Accessibility Survey

6th Street - Brookshire Avenue to Downey Avenue

Date of Inspection 7/18/2017

Prepared By Disability Access Consultants (800) 743-7067

Change in Level East of Dolan Avenue @ 33.944349012750, -118.128579407930

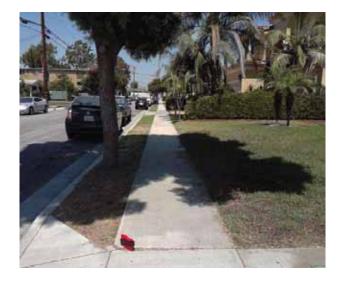
There is a change in elevation greater than recommended value.

On-Site Finding 0.87 inches

Ensure that the change in elevation is within the recommended value.

Recommendation Up to 0.25 inches

Change in Level East of Dolan Avenue @ 33.944357913180, -118.128590136766

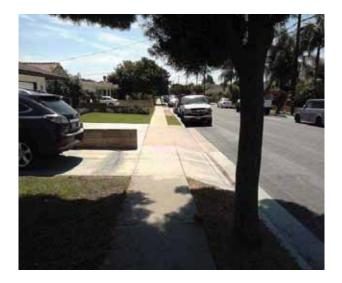
There is a change in elevation greater than recommended value.

On-Site Finding 0.50 inches

Ensure that the change in elevation is within the recommended value.

Recommendation Up to 0.25 inches

Change in Level West of Brookshire Avenue @ 33.943483441408, - 118.127152472734

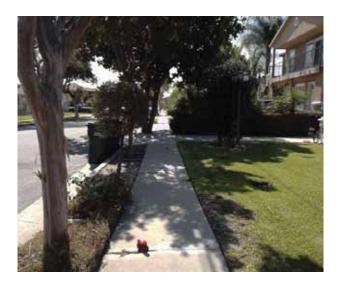
There is a change in elevation greater than recommended value.

On-Site Finding 0.75 inches

Ensure that the change in elevation is within the recommended value.

Change in Level West of Dolan Avenue @ 33.944009683131, -118.128175735474

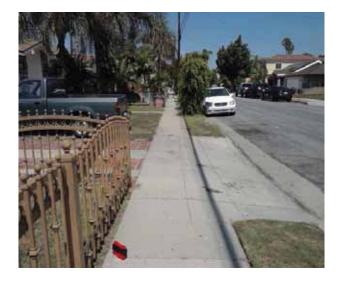
There is a change in elevation greater than recommended value.

On-Site Finding 0.37 inches

Ensure that the change in elevation is within the recommended value.

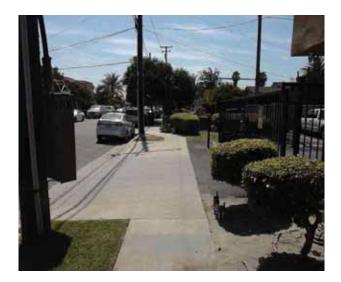
Sidewalk running slope is not compliant.

On-Site Finding 6.60 percent for 3.00 feet

Repave the sidewalk surface with the recommended running slope.

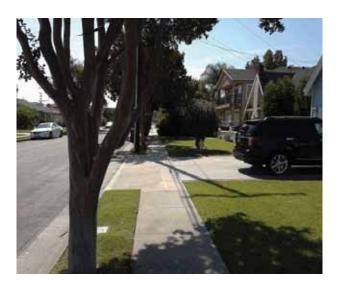
Overhead obstruction height is not compliant.

On-Site Finding 62.00 inches

Provide a compliant vertical clearance height.

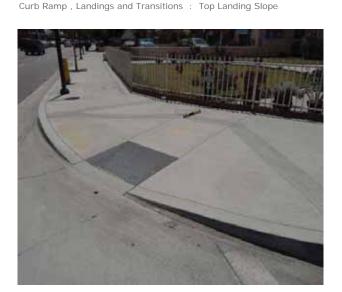
The slope at the top landing is greater than allowed.

On-Site Finding 3.00 percent

Provide a top landing surface that does not exceed the maximum slope and cross slope. Provide a sufficient maneuvering clearance that does not accumulate water.

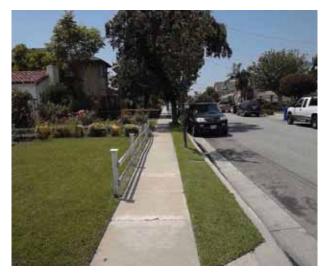
Sidewalk cross slope is not compliant.

On-Site Finding 4.30 percent for 122.00 feet

Repave the sidewalk surface with the recommended cross slope.

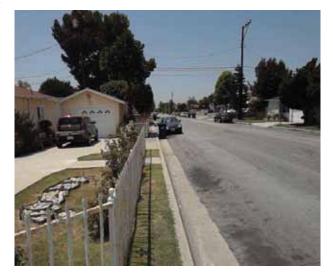
There is no 60X60 turn area at every 200 feet.

On-Site Finding Not Found

Provide a 60X60 turn every 200 feet on the sidewalk.

Change In Level West Of Smallwood Avenue @ 33.949326433401, - 118.138506263494

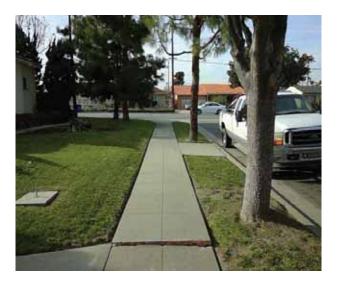
There is a change in elevation greater than recommended value.

On-Site Finding 2.75 inches

Ensure that the change in elevation is within the recommended value.

Change in Level East of La Reina Avenue @ 33.945521636492, -118.130710422993

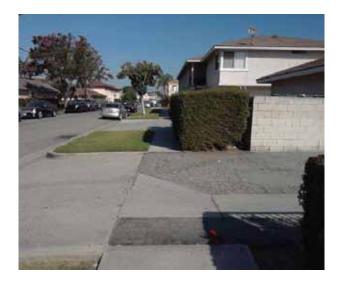
There is a change in elevation greater than recommended value.

On-Site Finding 0.75 inches

Ensure that the change in elevation is within the recommended value.

Sidewalks , Hazards & Gratings : Curb is on Path of Travel

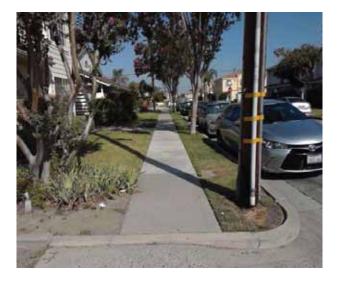
There is a curb on the designated path of travel.

On-Site Finding Not Compliant

Provide a compliant curb ramp.

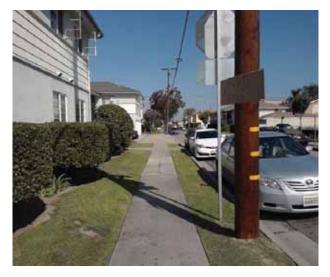
There is no 60X60 turn area at every 200 feet.

On-Site Finding Not Found

Provide a 60X60 turn every 200 feet on the sidewalk.
